Parkland Addition Replat E

City of El Paso — City Plan Commission — 2/8/2018

SUSU18-00007 — Resubdivision Combination (REVISED)

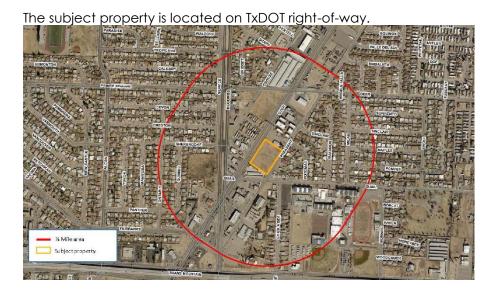
- To waive a 5' landscape parkway along Dyer Street.
 - > Currently, there is no landscape parkway.

The applicant does not meet the criteria under Section 19.10.050 (Roadway participation policies – Improvement of roads and utilities within and or abutting the subdivision) for requesting exceptions. The section reads as follows:

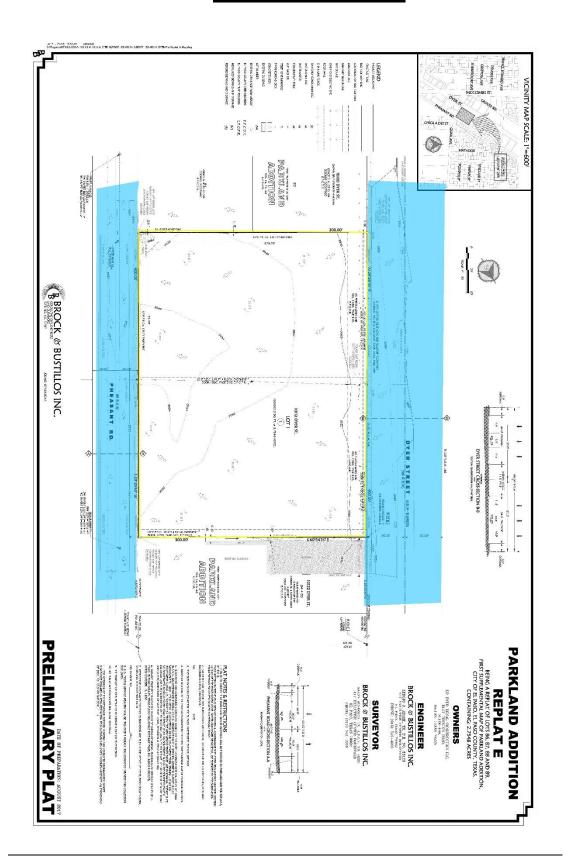
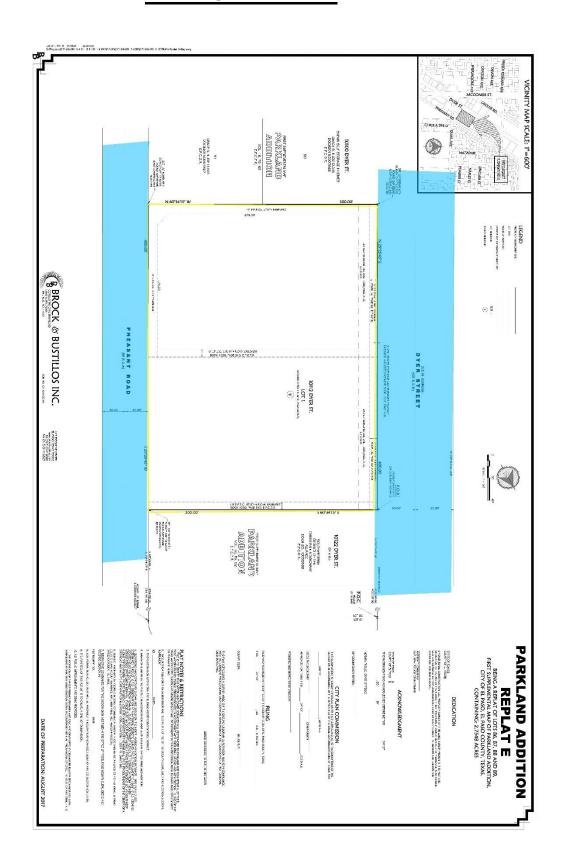
Planning staff recommends approval of Parkland Addition Replat E.
